Access Compliance Report

Public Rights-of-Way

(Curb Ramps)

Intersection ID: 23833	Main Street: FOXRIDGE_RD	Cross Street: MCALPINE_FARM_RD	Location: NW
ADA ID: CA1110DA1EB1	Ramp Type: Perp	Initial Pass/Fail: Fail	Overall Compliance: No
Severity Score: 12.5			
Codes/Mitigation Info/Possible Solution		Field Measurements/Component Compliance

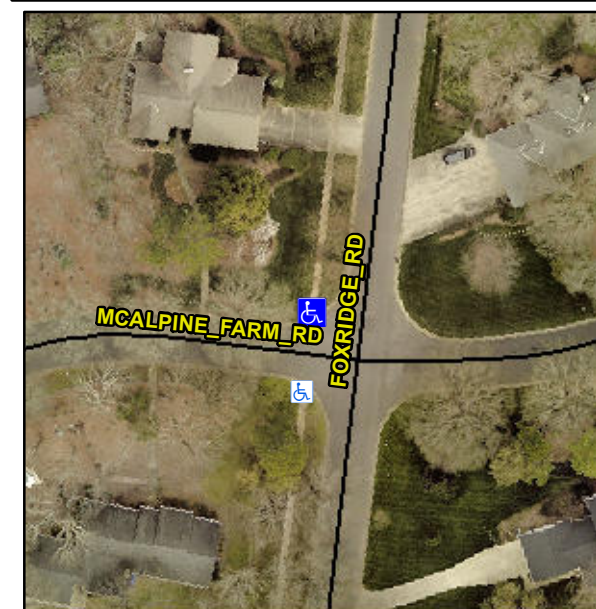
Possible Solutions:

Remove & Replace Entire Ramp.

PROW/ADA:

R304.5.3

Compliance	Description	Data	Compliance	Description	Data
N/A	Ramp Length (in)	44.0	Yes	Ramp Slope (%)	5.5
Yes	Ramp Width (in)	53.0	No	Ramp XSlope (%)	6.5
N/A	Flare Type LT	N/A	N/A	Flare Type RT	N/A
N/A	Flare Slope LT (%)	N/A	N/A	Flare Slope RT (%)	N/A
N/A	Flare Traversable LT?	N/A	N/A	Flare Traversable RT?	N/A
N/A	Landing Length (in)	N/A	N/A	DWS Provided?	N/A
N/A	Landing Width (in)	N/A	N/A	DWS Contrast?	N/A
N/A	Landing Slope (%)	N/A	N/A	DWS Length (in)	N/A
N/A	Landing X Slope (%)	N/A	N/A	DWS Full Width?	N/A
N/A	Landing Curb? (Y/N)	N/A	N/A	DWS Offset (in)	N/A
N/A	Shared Landing?	N/A			
N/A	Gutter Ponding?	N/A	N/A	Gutter Slope (%)	N/A
N/A	Gutter Lip Ht (in)	N/A	N/A	Gutter X Slope (%)	N/A
N/A	Painted X Walk1?	No	N/A	Painted X Walk2?	N/A
	X Walk 1 Direction	To SW		X Walk 2 Direction	N/A
N/A	X Walk 1 Width (in)	N/A	N/A	X Walk 2 Width (in)	N/A
	X Walk 1 Slope (%)	1.5		X Walk 2 Slope (%)	N/A
	X Walk 1 X Slope (%)	0.8		X Walk 2 X Slope (%)	N/A
